PALOMAR ENERGY PROJECT (01-AFC-24) CEC STAFF DATA REQUEST NUMBER 4	
Technical Area: Air Quality	Response Date: April 8, 2002

Subject: Cooling Tower Emissions

Calculated Particulate Size for Typical Cooling Tower Drop Size Distribution

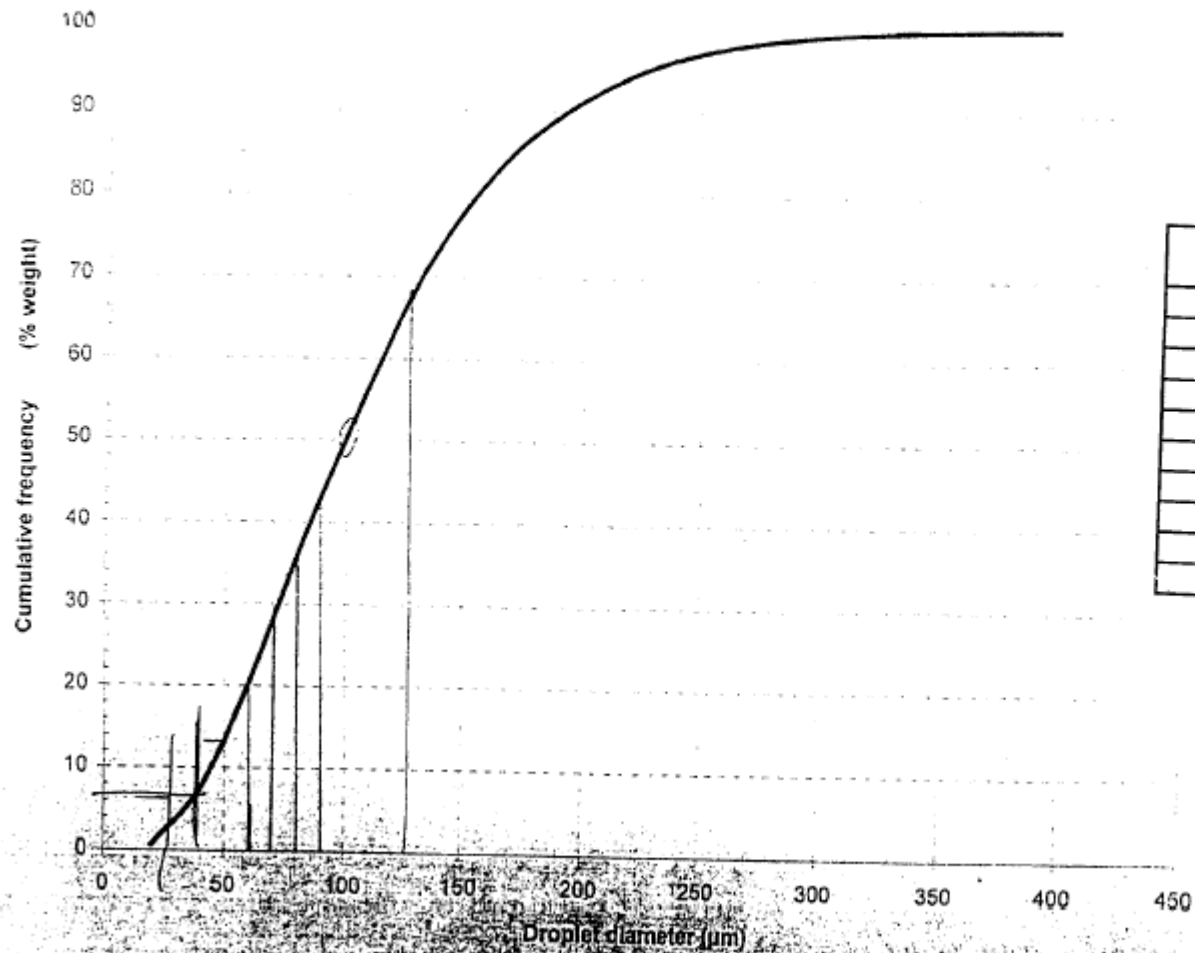
Please demonstrate that cooling tower PM₁₀ emissions are conservatively estimated by providing a discussion and references to documentation supporting the assumption that 50 percent of the TDS are PM₁₀. Please also provide information demonstrating that the SDAPCD and U.S. EPA have verified this assumption. If this information cannot be provided, please reassess impacts assuming 100 percent of the TDS are PM₁₀.

In support of the Blythe Energy Project, a technical paper (Attachment 4-1) was written and presented at the 94th Annual Air & Waste Management Association's Annual Meeting (June 2001). Based on the information and methodology presented in this paper, a PM₁₀ to TDS ratios of about 46% was derived as shown in the following calculations. Therefore, the 50% used for the Palomar project is supported empirically, is a level accepted by EPA, and is consistent with other projects approved by the Energy Commission and other agencies.

(e) PM-10 based on ~46% of TSP. Assumed that PM-10 generated by water droplets with a diameter of less than ~87 microns which account for 46% of emitted from typical cooling tower.

DP Microns	%Mass Smaller than
10	46.437
